# TECHNICAL BULLETIN

## Number 1226

- TO:** ALL COBRA WARRANTY STATIONS  
MODEL 140GTL - 142GTL - 148GTL.
- SUBJECT:** REGULATOR IC SHORTING OUT IN THE 140GTL, 142GTL, AND 148GTL. IC-5 (140, 142GTL), IC-4 (148GTL).
- SYMPTON:** HIGH AM POWER OUTPUT (10 WATTS) AND LOW MODULATION WEAK OR NO RECEIVE.
- SOLUTION:** REPLACE IC-5 (IC-4 FOR 148GTL) AND CHANGE D-60 (D-44 FOR 148GTL) TO A 18.2. VOLT ZENER DIODE. ADD A SR1K2 DIODE FROM PIN 1 TO PIN 2 OF IC-5 (IC-4 FOR 148GTL). (USE DIODE REMOVED FROM D-60/44).
- ADJUSTMENTS:** NONE REQUIRED.

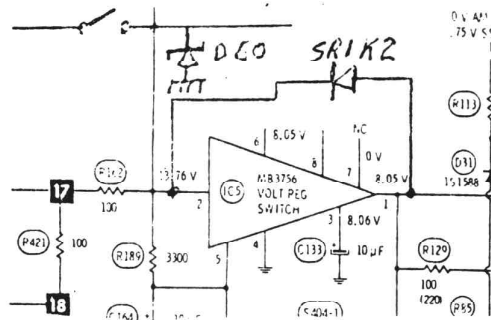
**NOTE:** THIS MODIFICATION SHOULD BE DONE ON ALL RADIO'S IN FOR IN-WARRANTY REPAIR. IF IC-5 (IC-4) CHECKS GOOD, ONLY MAKE DIODE CHANGES.

DYNASCAN PART NOS. SR1K2 151-045-9-001  
SUB. 16.2 VOLT ZENER 152-057-9-001. 18.2 VOLT ZENER (P/N N.A. AS YET)  
TO BE USED WHEN IN STOCK
